Liz Knitting & Printing Industry.

Holding-1,Block-C, Shaheed Mosharaf Hossain Road,
Purbo Chandora, Sofipur, kaliakoir, Gazipur.
(24.032036 N, 90.270180 E)
28 February 2022

Observations

Missing bracing at roof

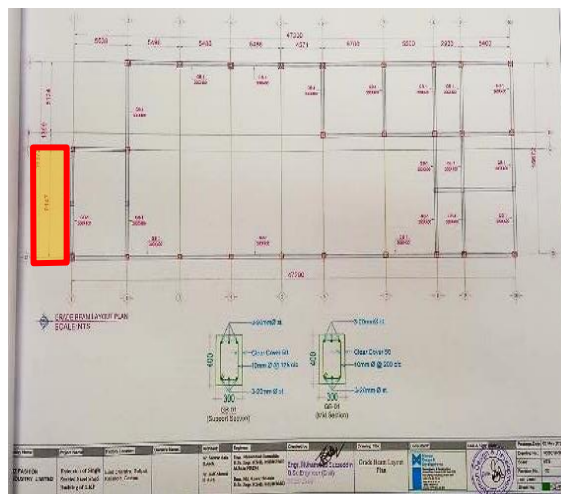
Missing compression strut on roof

The building engineer is required to check the stability of the structure. Also take proper remedial action where required.

Undocumented extension

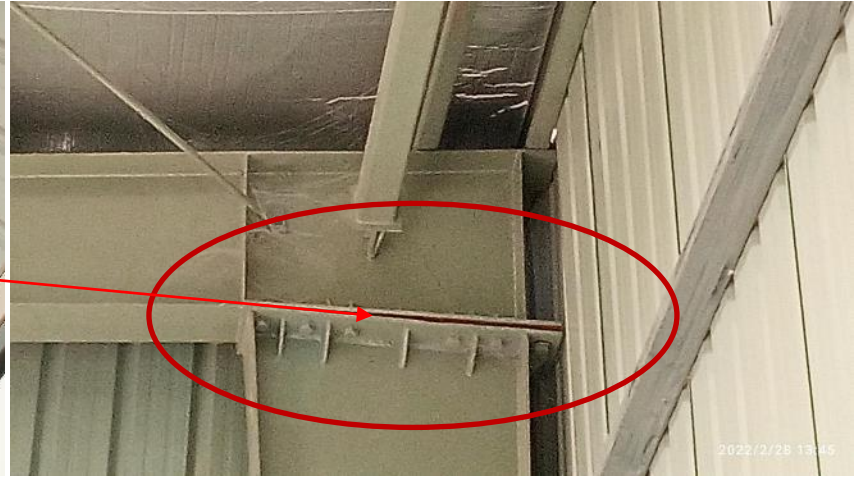
Missing bracing at roof

Missing bracing & undocumented extension of shed has been found on south side of the structure. The building engineer is required to survey the structure and produce accurate as built drawings.

Gaps between connection plates

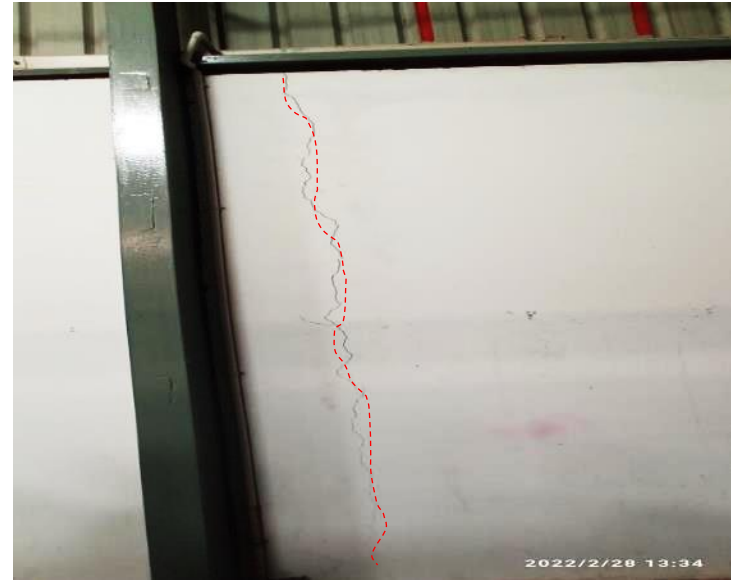
Significant gaps in connection & bolt missing

Missing bolts

Missing bolts and connection gaps in several locations were observed. The building is required check the structure to identify the missing bolts & connection gaps and take necessary actions as per the engineer's suggestion.
